Brisbane Central Business District Bicycle User Group

Please accept this as the Brisbane Central Business District Bicycle User Group (CBD BUG) submission regarding the proposed development at the Eagle St Pier under application number A005477682. In line with the CBD BUG's standard practice this submission will only outline concerns regarding the development and how they impact on cycling.

Figure 1 – Eagle St – Existing Conditions

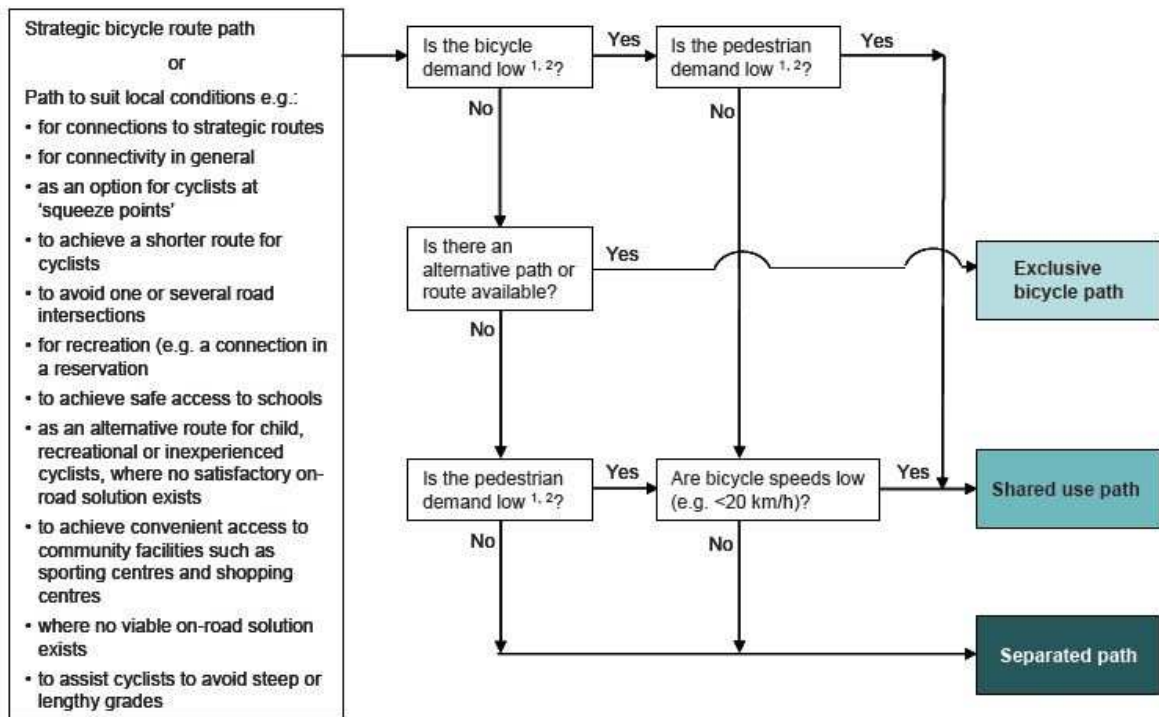
The existing Riverwalk forms a vital active transport function for people traveling to/from/through Riverside to/from/through the Brisbane City Gardens. It is the only corridor that does not pose the risk of conflict with and/or potential for injury from a motor vehicle. Currently, the Riverwalk through the Eagle Street Pier splits into an upper and a lower path (Figure 1). The upper path is predominately used by people wishing to linger and stroll. The lower path is predominately used by people to travel through the precinct whether they be on foot or bicycle. While the lower path is a substandard width, the separation of functions removes much conflict which would exist if the two paths had been built as one. Currently, the upper path is a minimum width of 3m and the lower path a minimum width of 2.5m providing a combined width of 5.5m for the Riverwalk.

Figure 7 - TMR

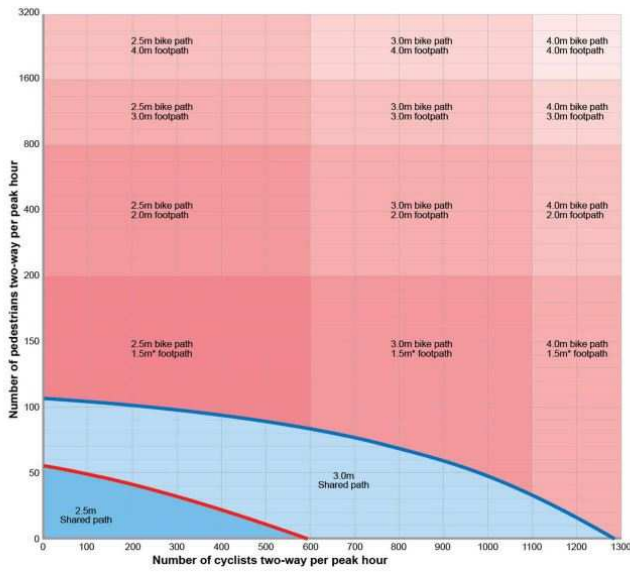
2d.1. TMR supplement to Part 6a provides a number of graphics (Figure 7 and Figure 8) to determine suitable path widths which show that even at current volumes a separated path is recommended.

Figure 13 – CBD BUG CONCEPT AMENDMENTS

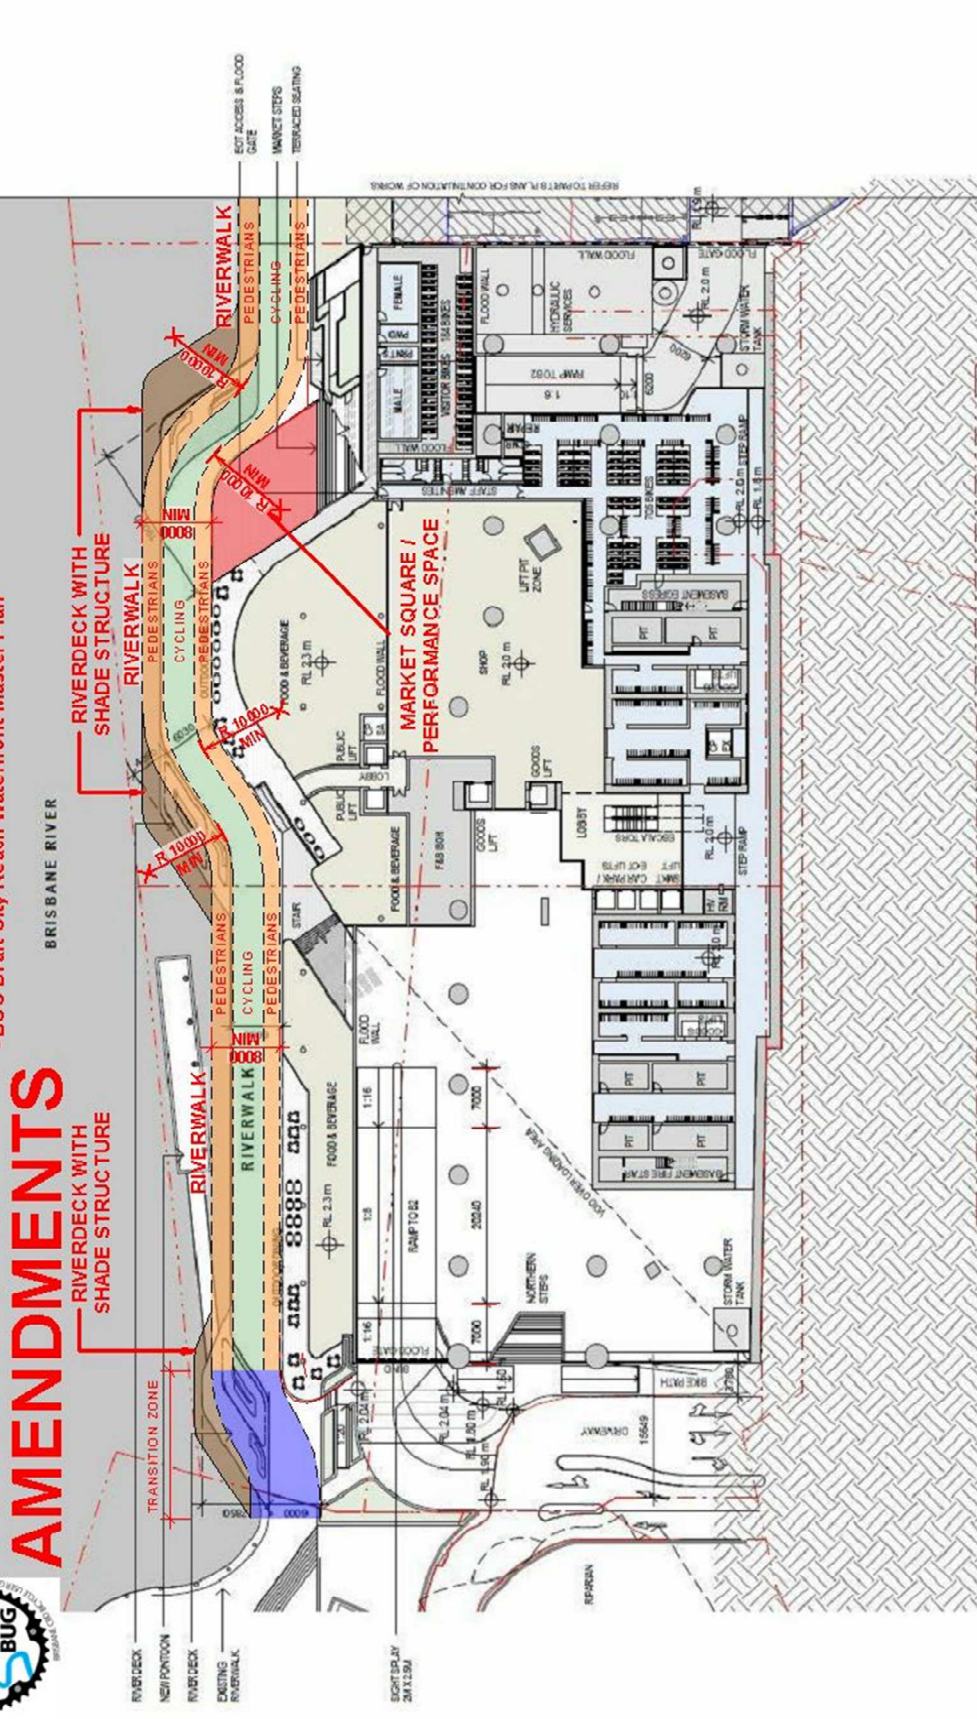
Every concern raised in this proposal could be easily resolved by a path that complies with Austroads Guidelines, TMR Guidelines and the City Reach Waterfront Master Plan (Figure 13 and 14). Such an example already exists in Vancouver Canada (Figure 15).

- COMPLYING WITH**
- Austroads Guidelines
 - TMR Guidelines
 - BCC Draft City Reach Waterfront Master Plan
